94 Tilehouse Street, Hitchin, Hertfordshire SG5 2DW
26th November 2024

In response to the conservation officer's further comments and objections dated 22/11/2024:

White ABS Grille

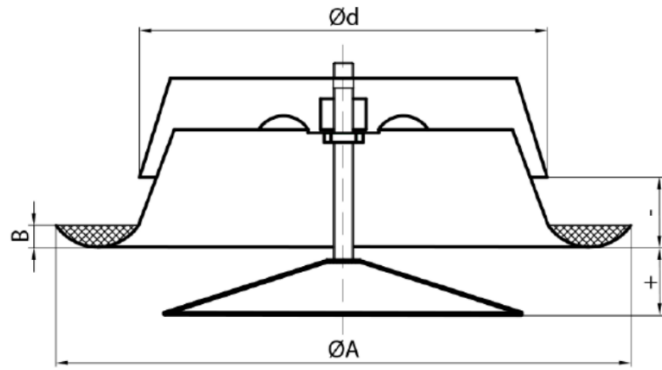
4. Whole house heat recovery ventilation systems provide energy efficient ventilation unobtrusively. They make buildings like this comfortable without the need to open windows, which can be useful in town centre locations which can be noisy. They have "HEP" filters which remove pollution and pollen. Their implementation needs to be encouraged. I have been incorporating them wherever possible in all of the buildings that I have been responsible for over the last forty years. Their benefits are energy efficiency, comfortable living conditions, quiet running, filtered air, they remove the need for vents through external walls to toilets and bathrooms and they are inobtrusive internally.

The grilles which would be used in the ceilings of this building would be circular white ABS plastic as this illustration, they are no more intrusive than light fittings and less obtrusive than smoke detectors:

Section through grille. The overall diameter of the ones used would be 137mm (for 100mm ducting)
